**BEFORE THE INDEPENDENT HEARING PANEL
FOR THE QUEENSTOWN LAKES PROPOSED DISTRICT PLAN**

Under the	Resource Management Act 1991
In the matter	of the Urban Intensification Variation to the proposed Queenstown Lakes District Plan

**REPLY EVIDENCE OF CORINNE FRISCHKNECHT
ON BEHALF OF QUEENSTOWN LAKES DISTRICT COUNCIL**

**PLANNING: TEXT – Queenstown Town Centre, Local Shopping Centre, Medium Density
Residential Zone, High Density Residential Zone**

Public Places

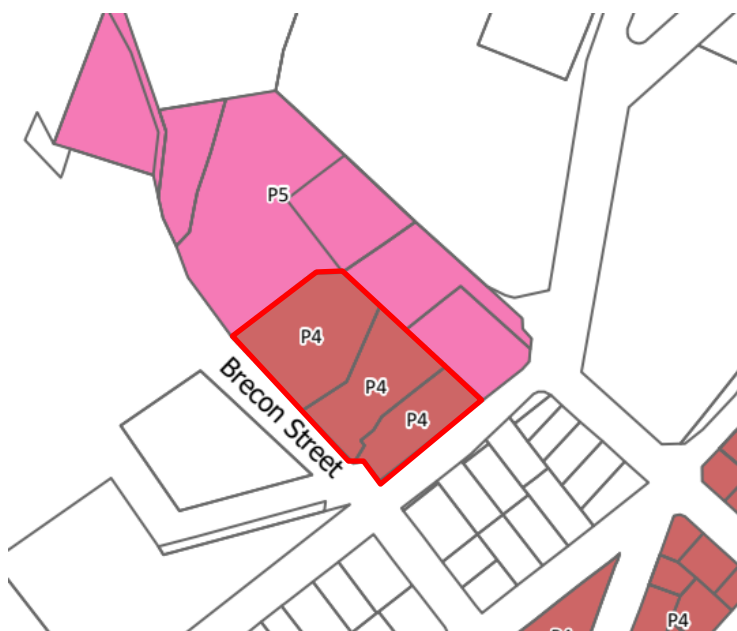
- 6.1** During questioning, Commissioner Munro drew my attention to my recommended change to s42A 12.2.2.3(c) in replacing the word ‘public places’ with ‘land zoned Open Space’ in regards to maintaining sunlight access. I understand that Commissioner Munro was not questioning my reasoning for changing it but more to ensure that a similar approach is taken for other zones, such as WTCZ. I have undertaken a review of the WTCZ framework and note that there are no other objectives or policies in Chapter 13 that seek to ‘maintain sunlight’ access on public place. Therefore, I do not recommend any further changes to Chapter 13 in regards to WTCZ.

- 6.2** Commissioner Munro also questioned the term ‘land zoned Open Space’ should be ‘land zoned Open Space and Recreation Zones’ to align with the PDP. I agree that using the term ‘Open Space and Recreation Zones’ would also capture the Recreation Zones and better align with Chapter 38 of the PDP and planning maps, as well as the intention of the of the policy.

- 6.3** I therefore recommend that Policy 12.2.2.3(c) be amended as follows:
- (b)*
 - (c) maintain sunlight access to land zoned within the Open Space and Recreation Zone ~~public places~~ and to footpaths, and with a particular emphasis on retaining solar access into the Special Character Area (as shown on the District Plan web mapping application); and*

Figure 1: Plan of areas in MDRZ areas in Arthurs Point proposed to be subject to specific rules in the hearing evidence of Mr John Edmonds.

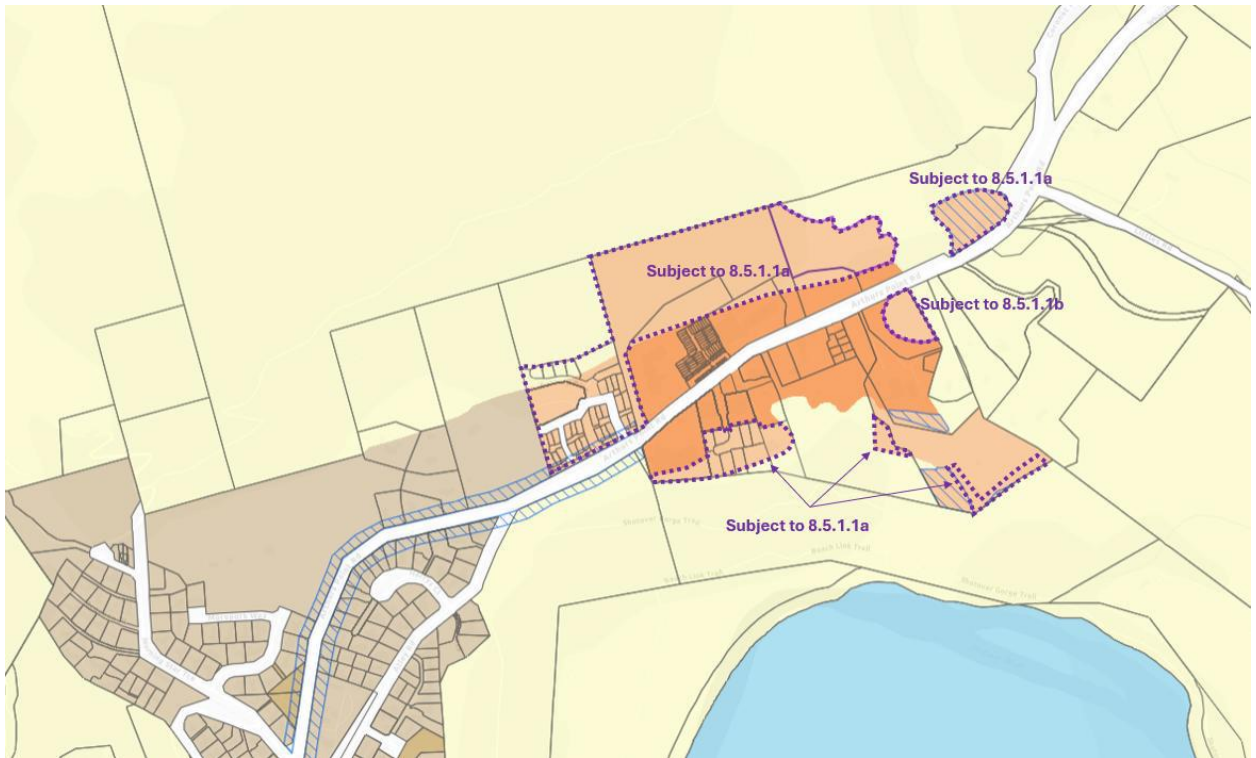
2. The proposed setback of taller built development from the terrace edge would minimise the visual impact of taller more bulky buildings from viewpoints below the site within the river corridor. However, this taller development would still be clearly perceived from viewpoints further to the west (Atley Terrace, Shotover Gorge Trail, Watties Track and McChesney Road area) and from the east (Littles Road). I also note that the proposed height setback does not extend along the entirety of the ONF boundary within or adjacent to the site (refer circled area in **Figure 2** below).

Figure 2: Close up of areas proposed to be subject to specific rules in the hearing evidence of Mr John Edmonds.

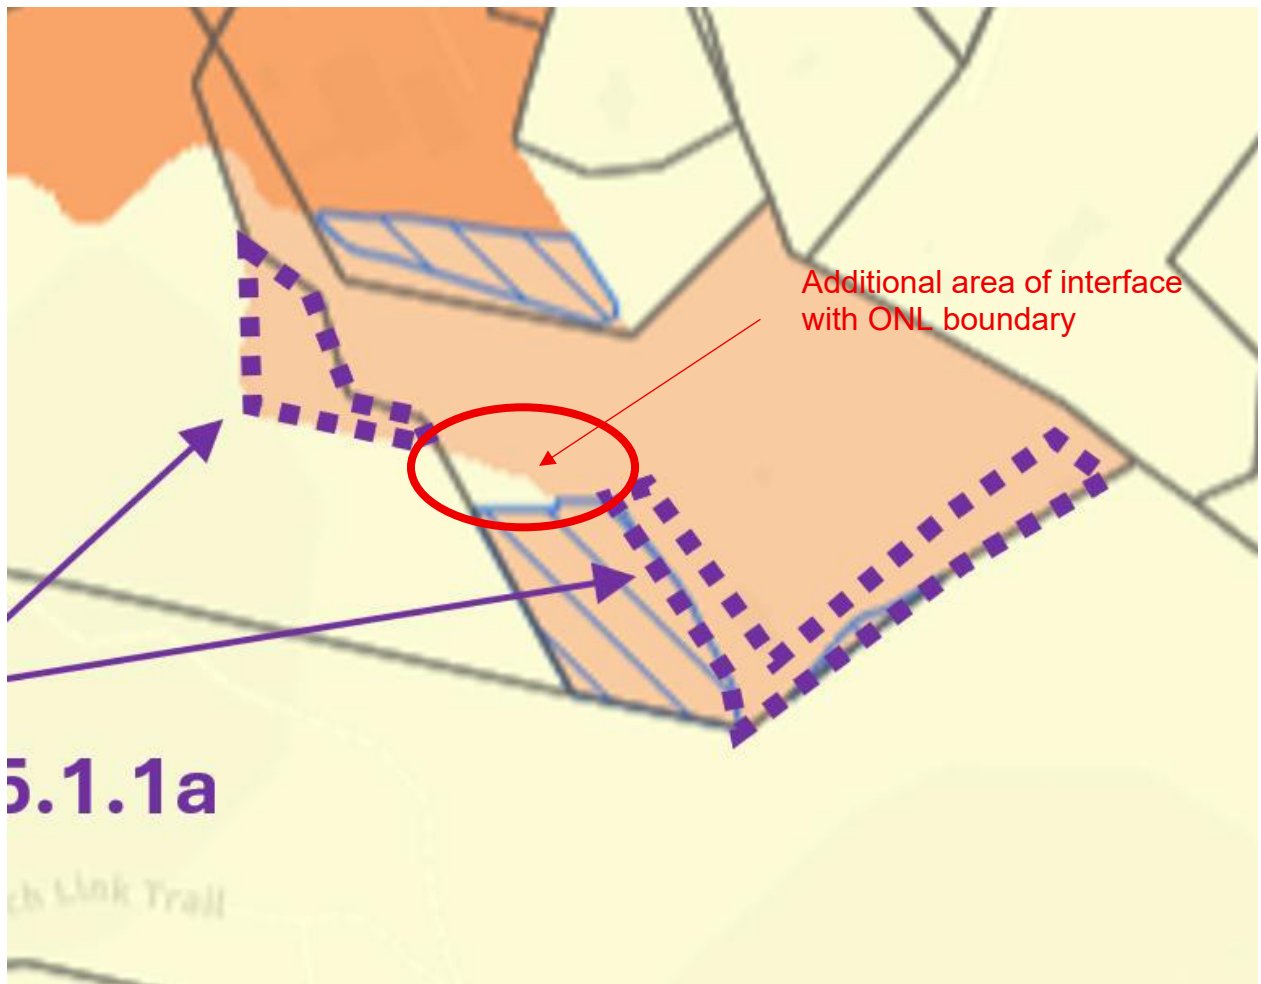
3. While there is potential for landscaping within the proposed 5m building setback from the eastern boundary to partially screen and integrate taller buildings near this boundary, there are no provisions that would ensure this outcome.
